Recommendation on DS3 System Services Protocol – Regulated Arrangements

DS3 System Services Implementation Project

March 29th 2019

TSOs' modified proposed text for SOR:

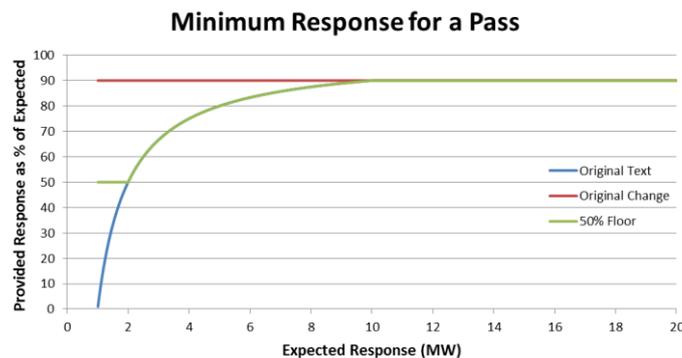
For component 2 of this change the TSO’s recommend that, a modification of the originally proposed change is applied. This modified change would retain the existing text but include a requirement that, in cases were a pass will be awarded for the achieved response being within 1MW of the expected response, the achieved response is at least half of the expected response.

This modified change is proposed as industry raised some relevant points on the greater impact of measurement errors for providing units with small expected responses, especially if the frequency is only below the unit’s reserve trigger for a short period of time. The modification is described below.

- i. If the Expected SOR Response minus the Achieved SOR Response is less than or equal to 1 MW, and the Achieved SOR Response divided by the Expected SOR Response is greater than or equal to 0.5,

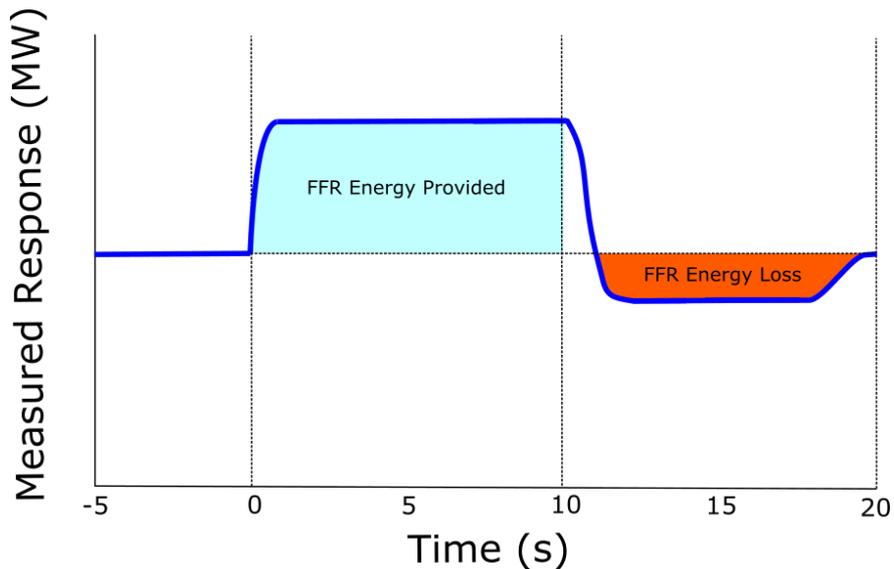
1. The TSOs agree that clear definitions of the Energy Provided and Loss of Energy would improve the clarity of the Protocol.
2. The TSOs agree that the description of how the tolerance is applied during the assessment of FFR provision (S_1) could be clarified.
3. The TSOs agree that the approach for assessing the FFR response time should be clearer.

The **FFR Loss of Energy** is defined as the energy not provided by a **Providing Unit** during the period of $T=10$ to $T+20$ seconds, when compared to the energy that would have been provided in this period based on the **Providing Unit Pre-Event Output**.

The **FFR Loss of Energy** can be calculated by taking the sum of the equation below for each sample point t where the result of the equation below is greater than zero (all negative values are discarded). Note, dt is the time between samples.

Threshold crossings constituting significant discrete change (5.7.1.3b)

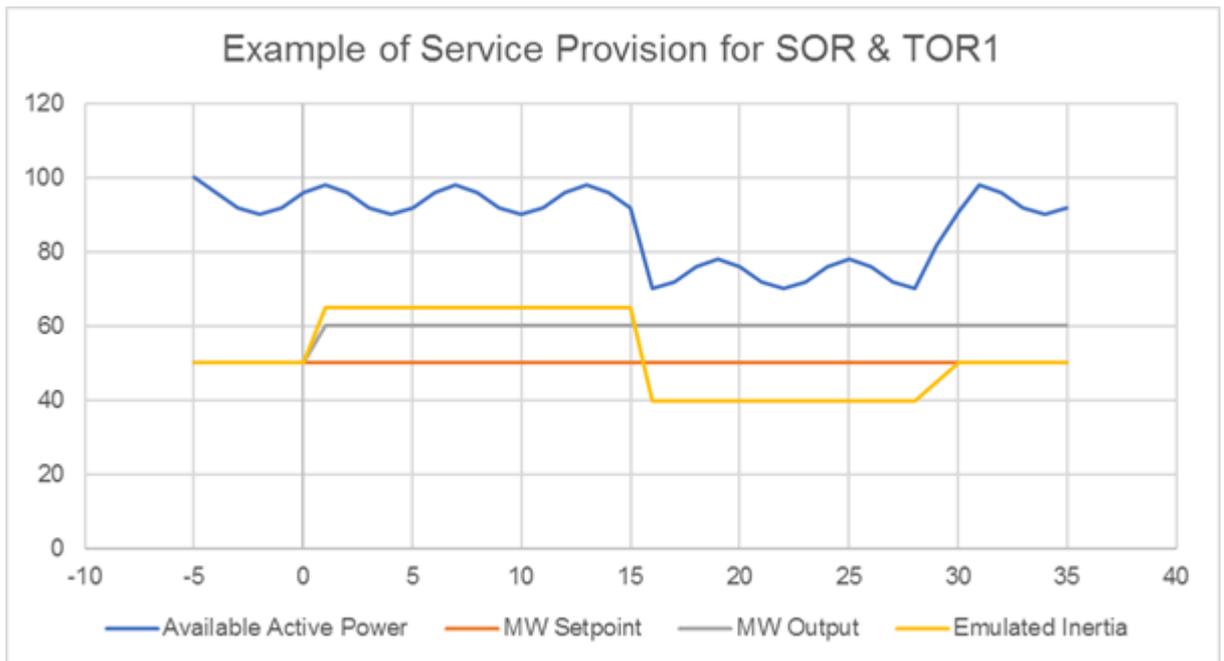
As above, this statement is quite vague. Specific criteria must be defined such that providing units can be configured to provide the correct response in real-time.
